Access Compliance Report

Public Rights-of-Way

(Curb Ramps)

Intersection ID: 11318	Main Street: GRANDIN_RD	Cross Street: W_4TH_ST_EXT	Location: NW
ADA ID: 585D08D77A51	Ramp Type: Para	Initial Pass/Fail: Pass	Overall Compliance: No
Severity Score: 0			
Codes/Mitigation Info/Possible Solution		Field Measurements/Component Compliance

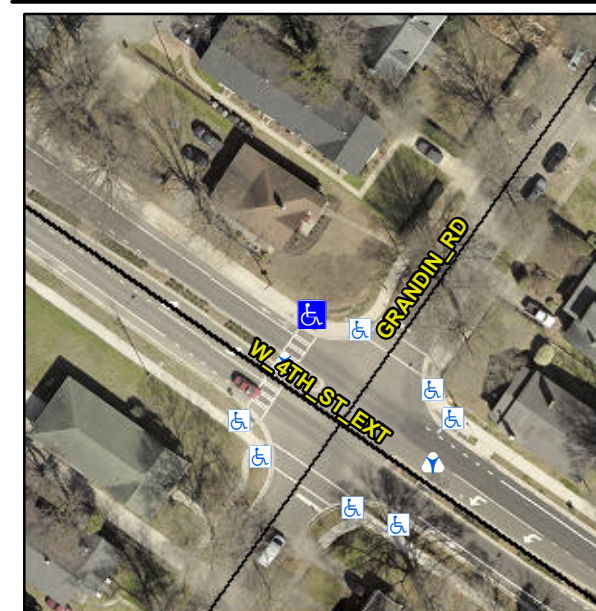
RT RP < 5%

R304.5.3

Remove & Replace Landing.
